ALLOWANCE AUTHORIZATION

Project: 2023 Capital Outlay Project	Field Order No.: 401-04
Owner: Ogdensburg City School District 1100 State Street Ogdensburg, New York 13669	Date: March 7, 2024
Contractor: Watson Electric 431 Douglas Road Norwood, New York 13668	Architect's Project No.: 2023-008
SED No.: 51-23-00-01-0-007-025 Ogdensburg Free Academy / Golden Dome	Contract For: No. 4 - Electrical
	Contract Date: July 3, 2023
	SED Project Manager: Wendy Clark

CHANGE ORDER CERTIFICATION

Change Order Number: 4-03

BOILER ROOM PLUMBING PLAN - NEW WORK

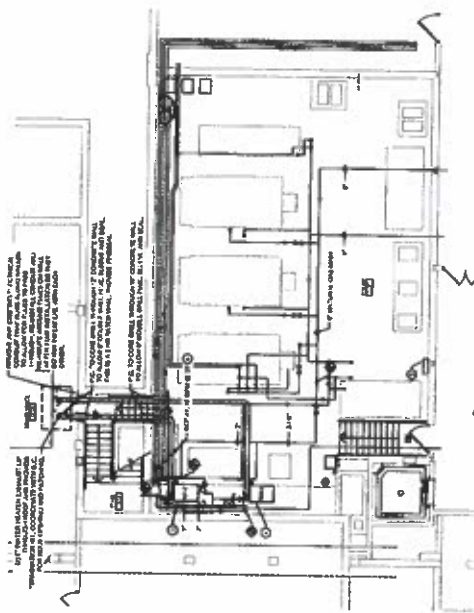
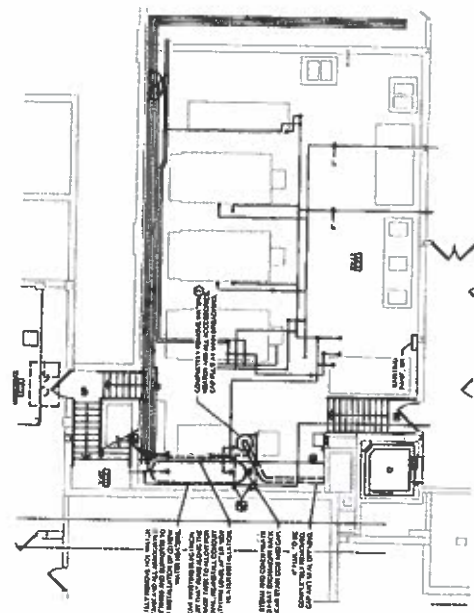
Add to provide all labor, materials, and equipment to provide electrical circuit to new condensate pump furnished by Plumbing Contractor due to lack of available floor drains at new water heater location. \$ 439.09

A	Plumbing Contractor/Owner requested.
B	Under the Capital Outlay Project, the existing domestic hot water system was scheduled to be replaced at Boiler Room E011 per Contract Drawings P100 and P101.
C	Due to equipment lead times, the Owner requested an alternate location for the water heaters inside Maintenance Room C004 to maintain continuity of the hot water service during installation. Due to the lack of a nearby floor drain, the condensate could no longer be gravity drained and a condensate pump was required.
D	Add for labor, materials, and equipment to provide electrical circuit to new condensate pump furnished by Plumbing Contractor due to the lack of available floor drains at new water heater location.
